# ISC-C1 Rack

Title <b>ISC System Wiring Diagram</b>		
Size B	Number <b>D1900511</b>	Revision <b>v1</b>
Date: 10/21/2020	Sheet of 1 TBD	
File: C:\Users\...ISC_C1_SHL.SchDoc	Drawn By: Filiberio Clara

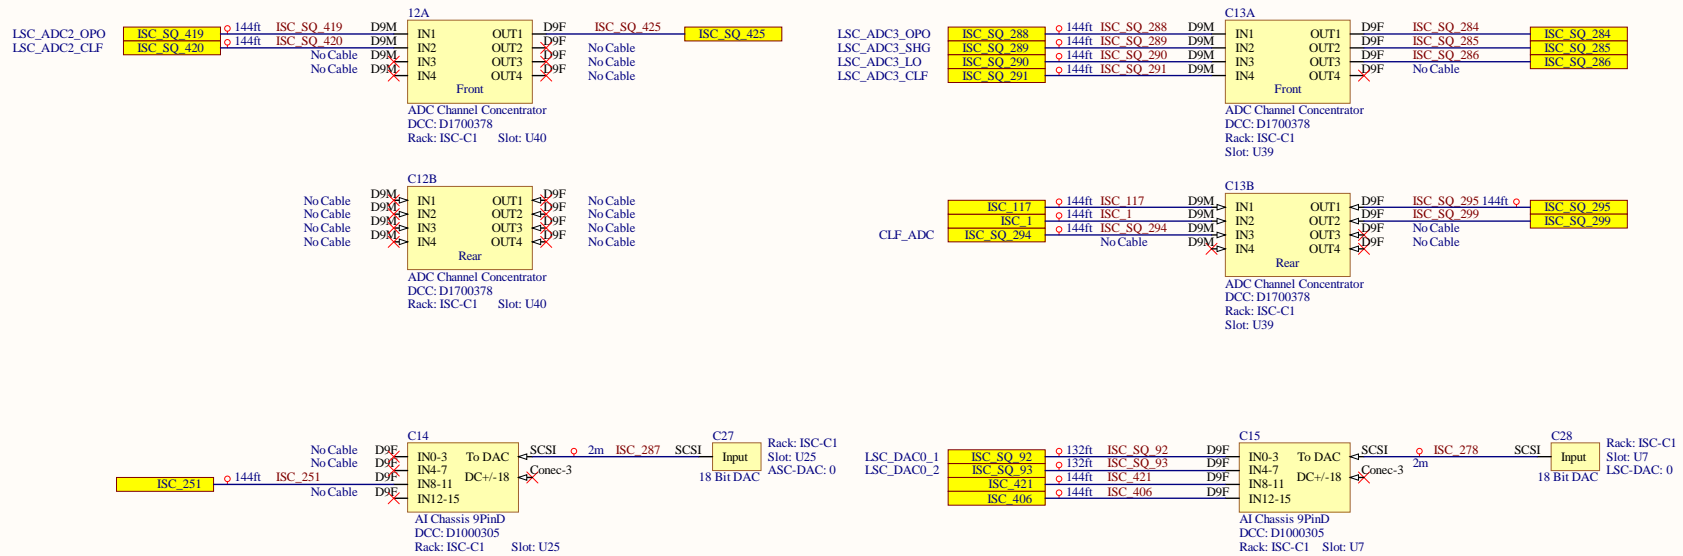
Needs Label

Following cables are not connected in the CER:  
 ISC\_101, ISC\_175, ISC\_242, ISC\_410, ISC\_426,  
 and ISC\_427

# ISC-C2 Rack

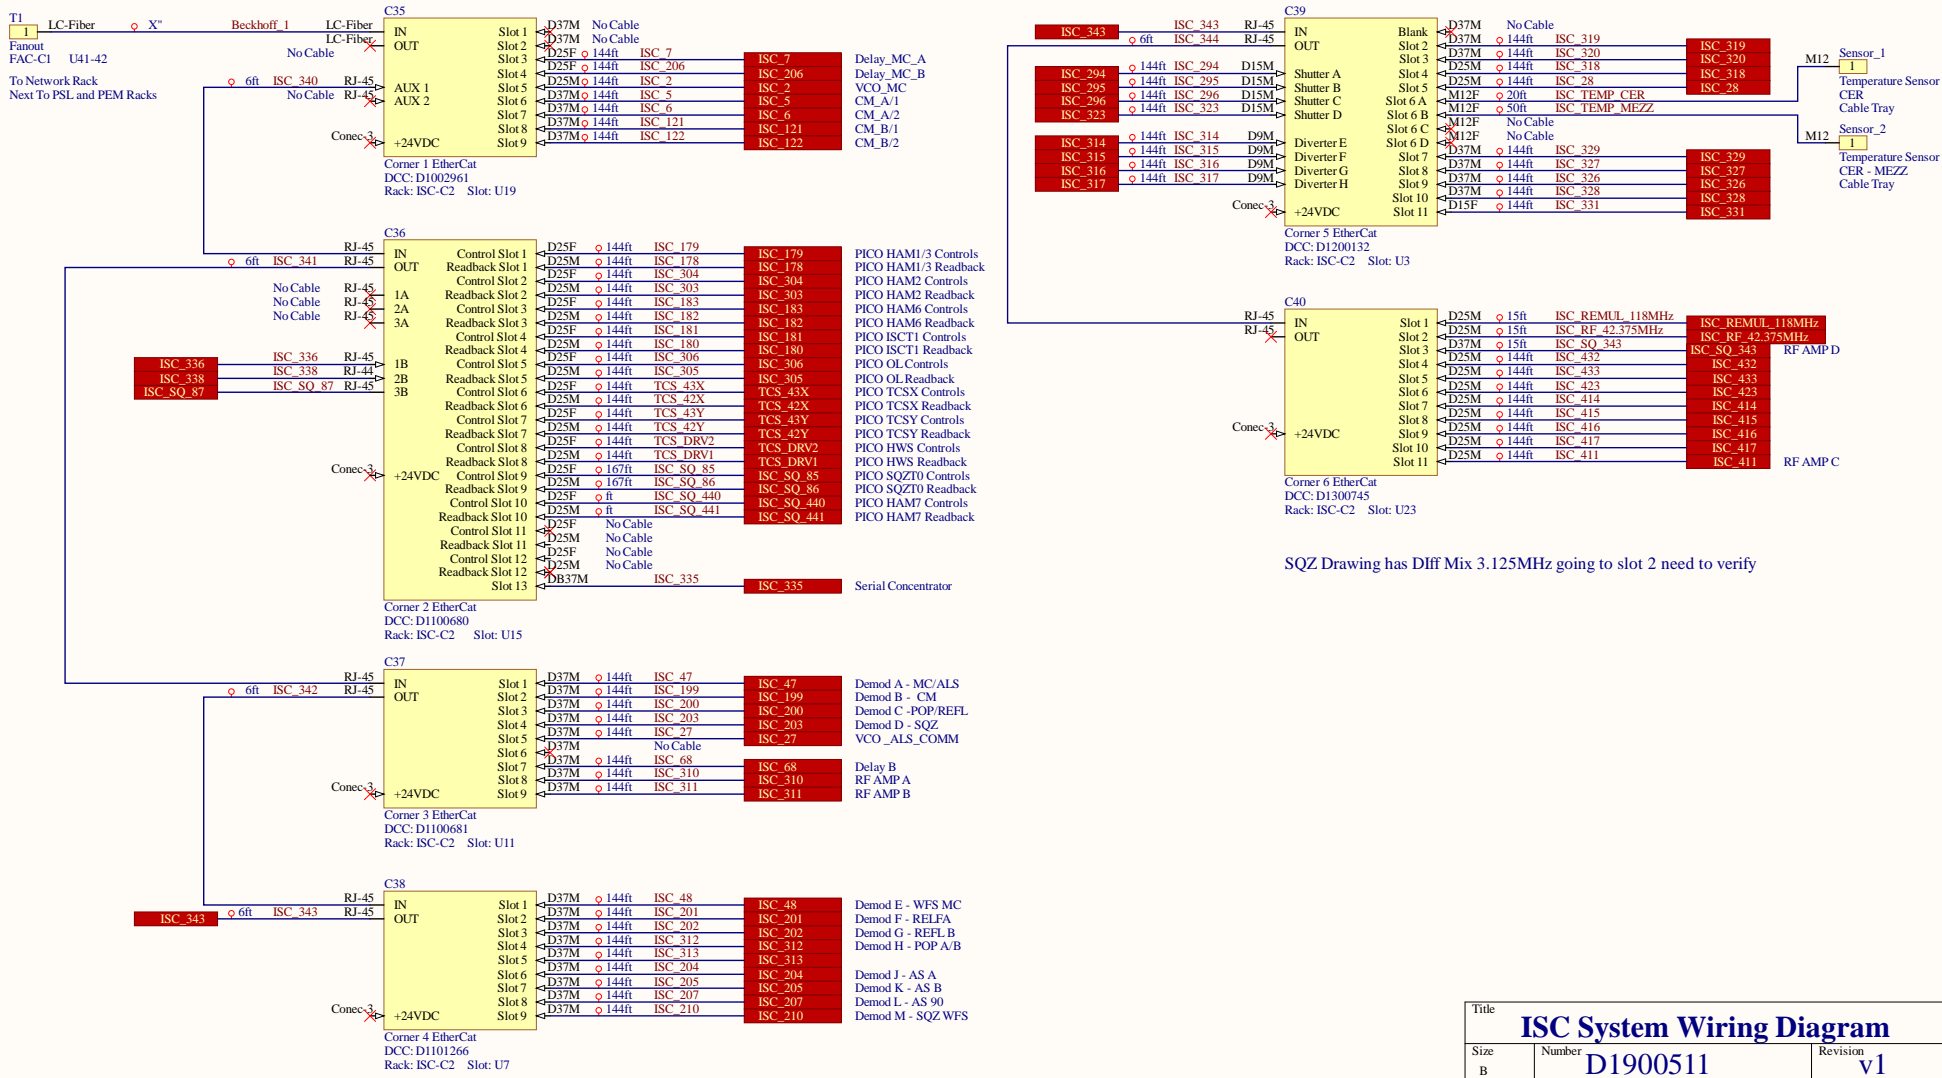
SQZ Drawing has Diff Mix 3.125MHz going to slot 2 need to verify

# ISC-C3 Rack

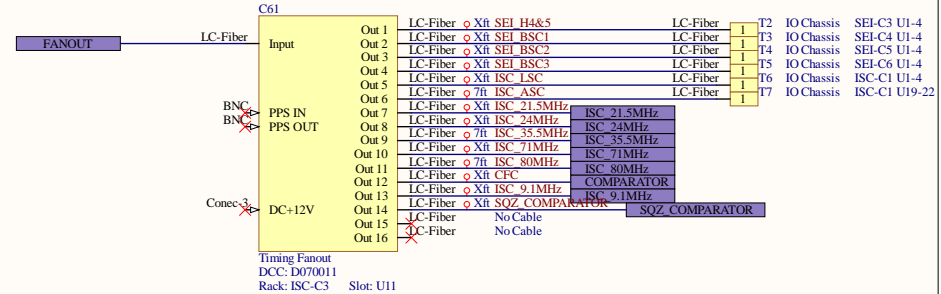
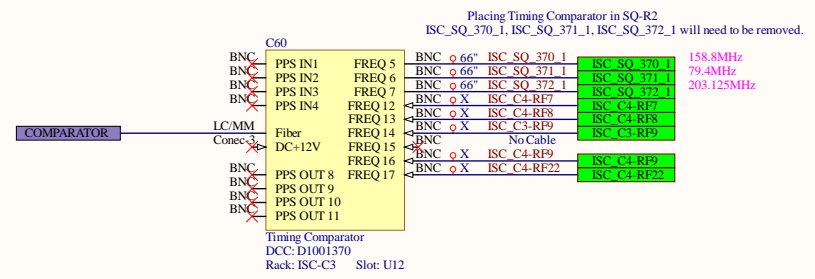
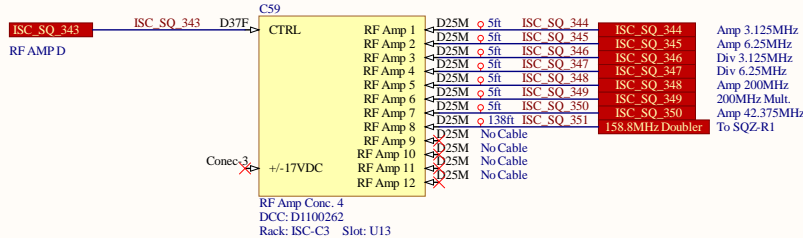
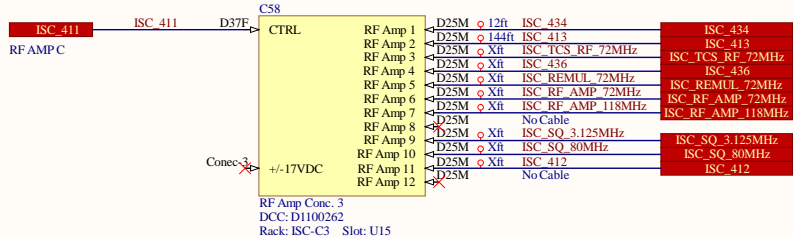
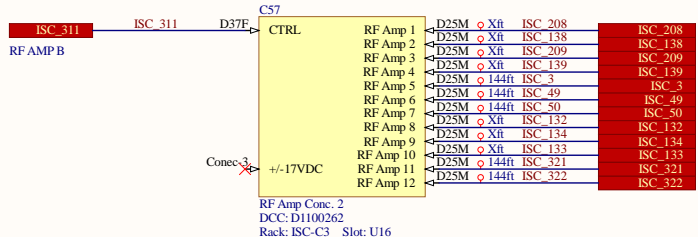
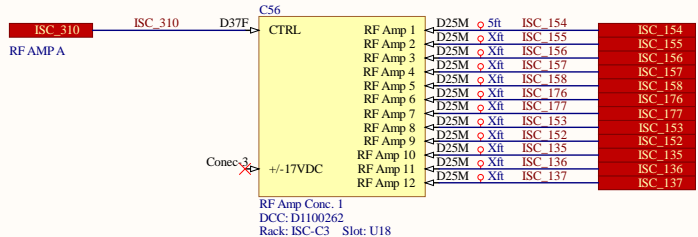
Need to label IFR cable with RF22

Title		
Size	Number	Revision
B	D1900511	v1
Date:	10/21/2020	Sheet of 0
File:	C:\Users\...ISC R1_SHL.SchDoc	TBD
Drawn By:		Filiberto Clara

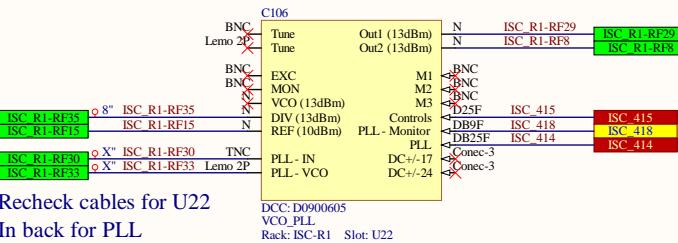
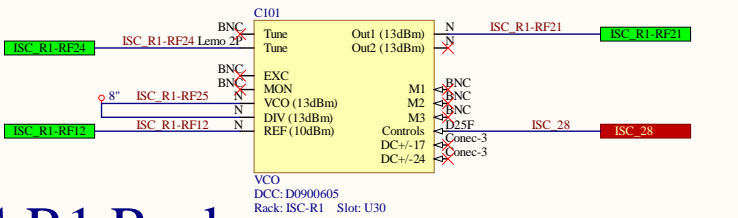
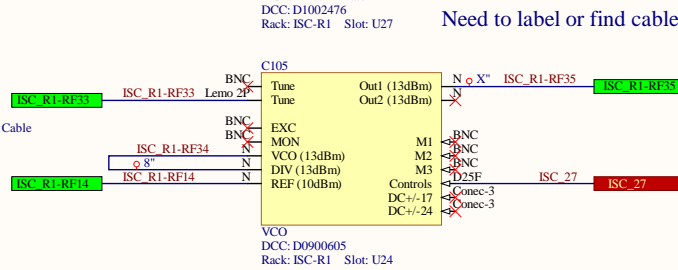
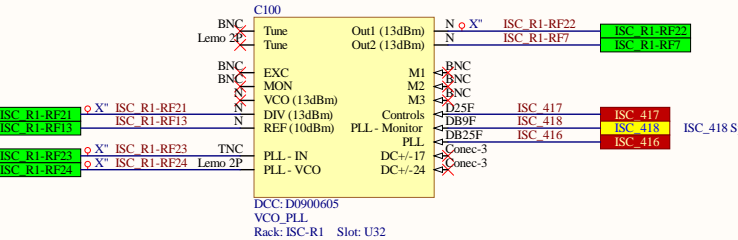
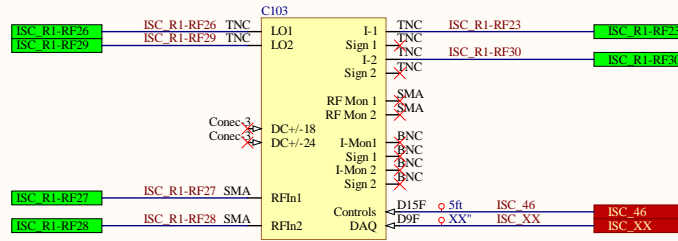
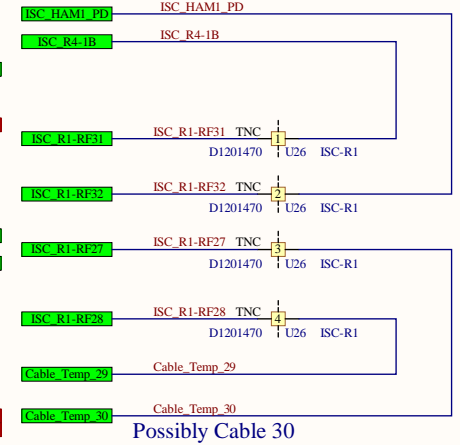
R1-RF5 and R1-RF6 go to PSL Rack R2  
U Slot U7 & U8, 9 MHz and 45 MHz

Need to label or find cable number

Recheck cables for U22  
In back for PLL

# ISC-R1 Rack

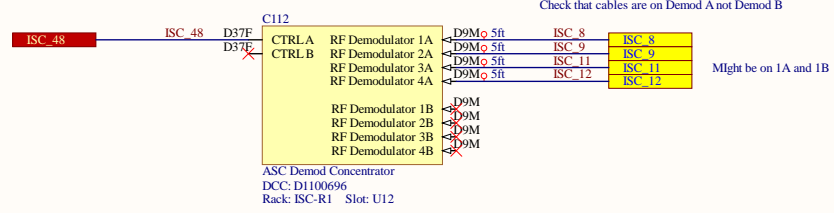
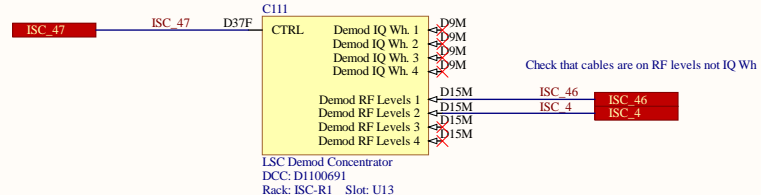
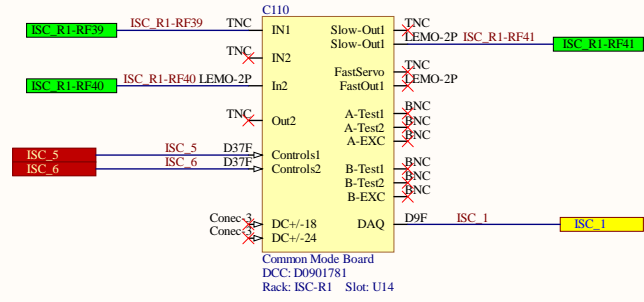
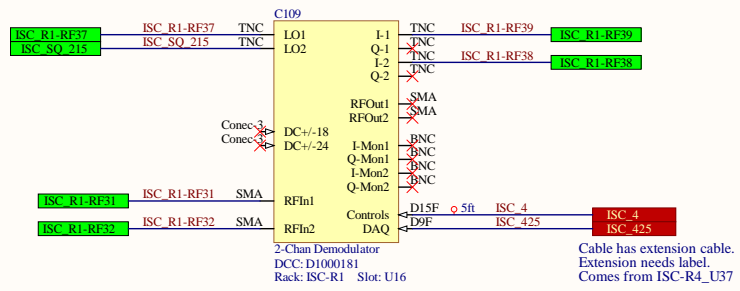
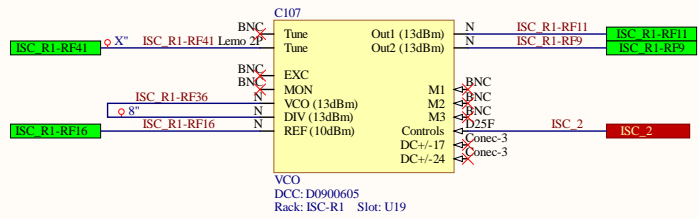
Need to Locate other end

# ISC-R1 Rack

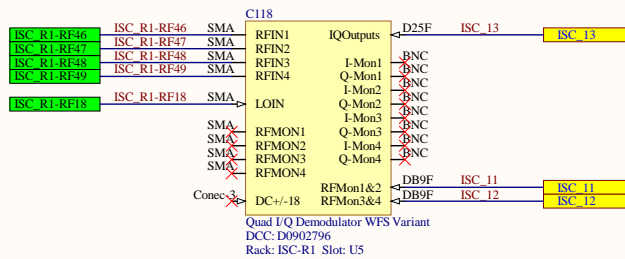
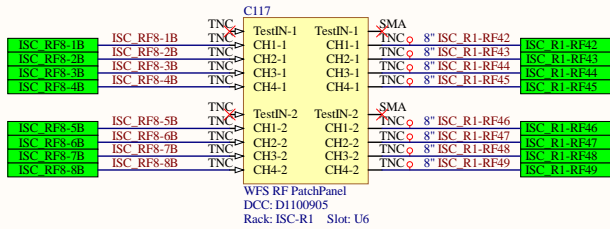
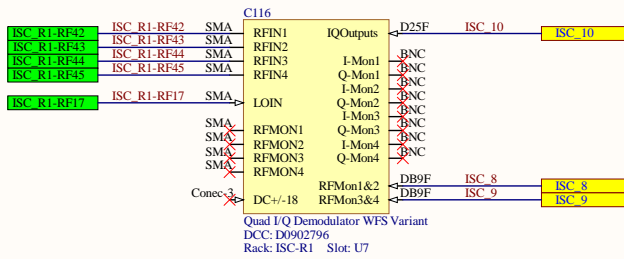
Need to locate other end

# ISC-R4 Rack

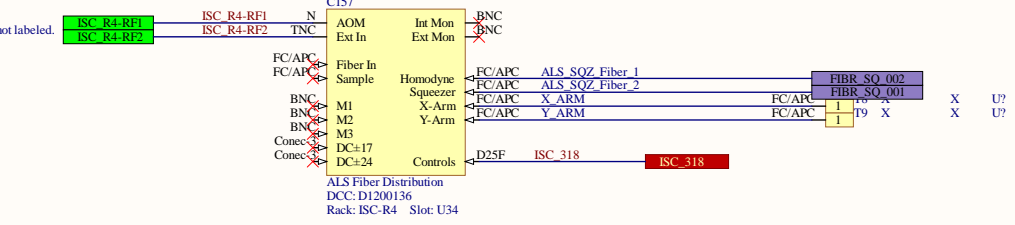
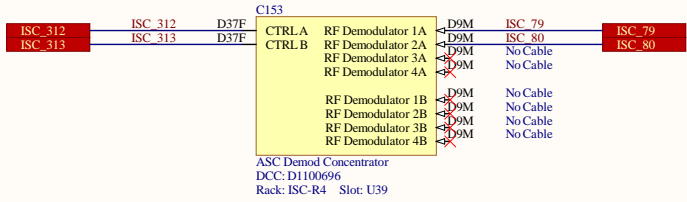
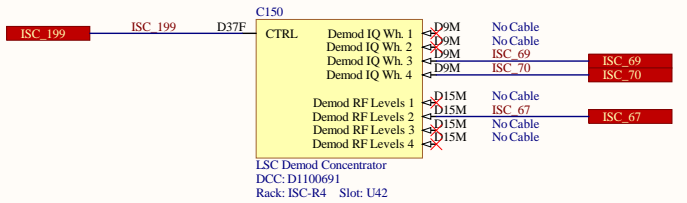
R4-RF2 Goes out of rack, other side not labeled.  
 Old label H1\_ALS\_PSL\_PD1

Both cable have no labels  
 Both go to R2\_U27

To ISCT1 and HAM1

# ISC-R4 Rack

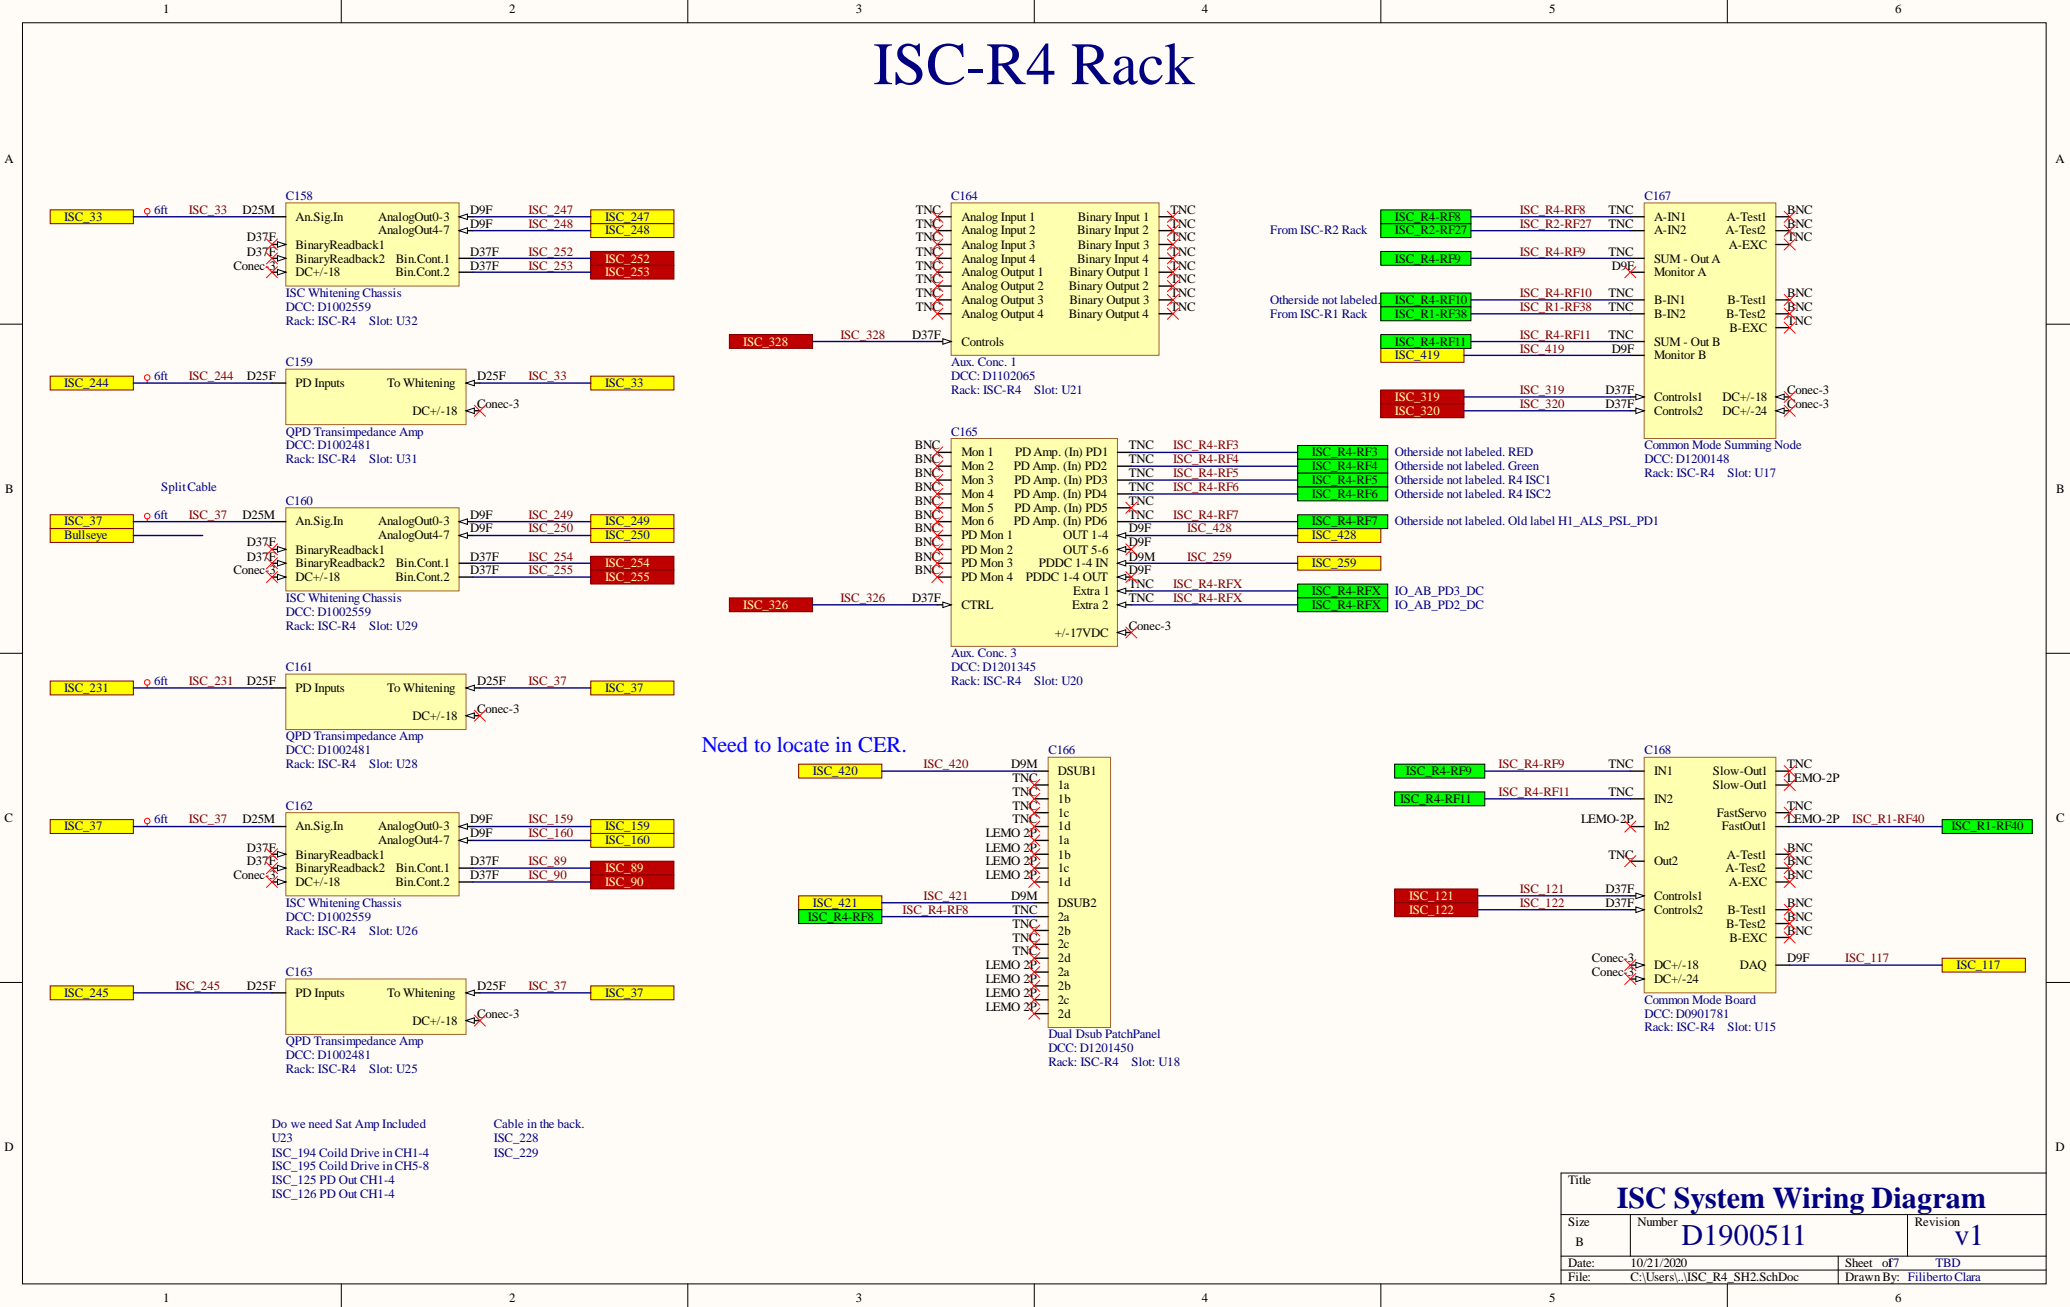
Need to locate in CER.

# ISC-R3 Rack

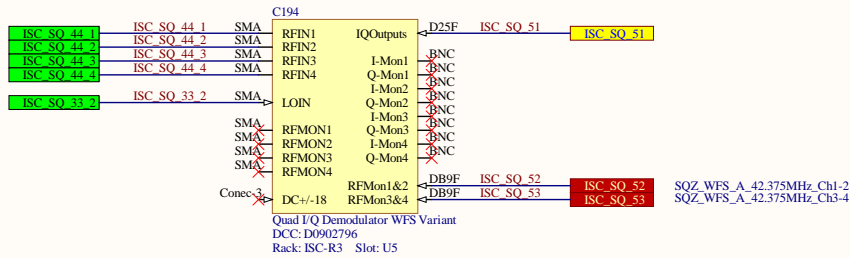
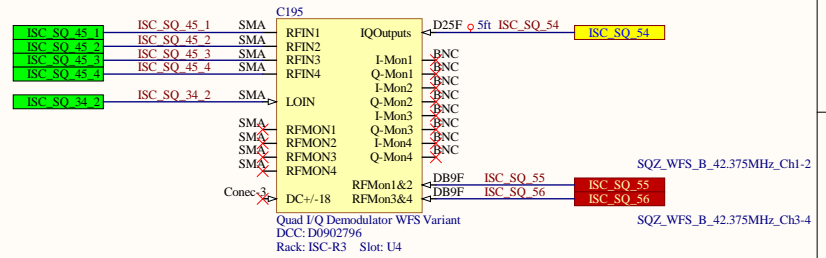
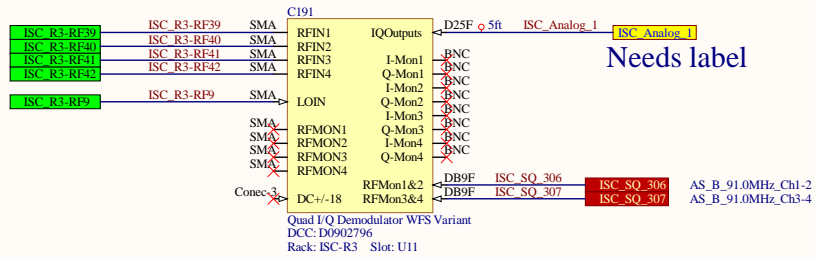
Needs labels

Needs label

# ISCT1 - Right Side

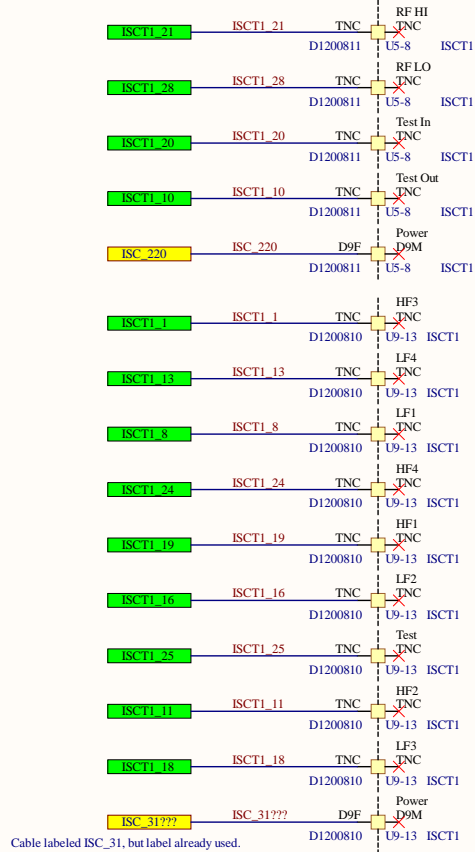
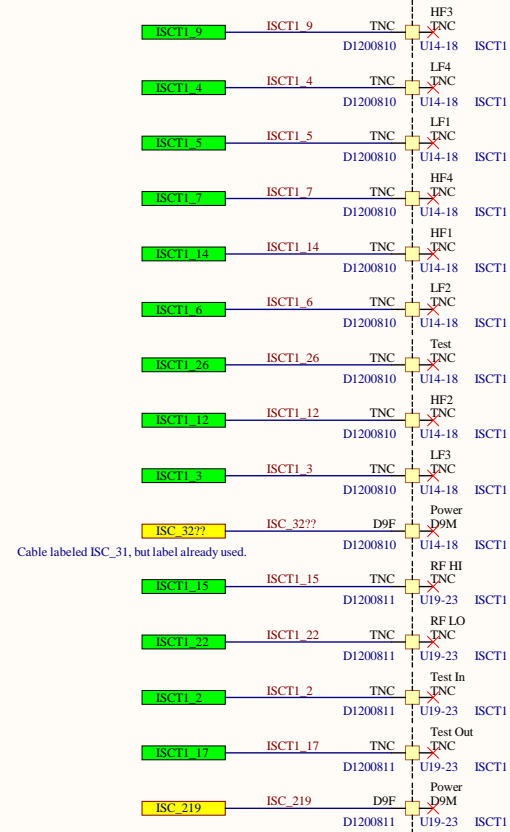
Cable labeled ISC\_31, but label already used.
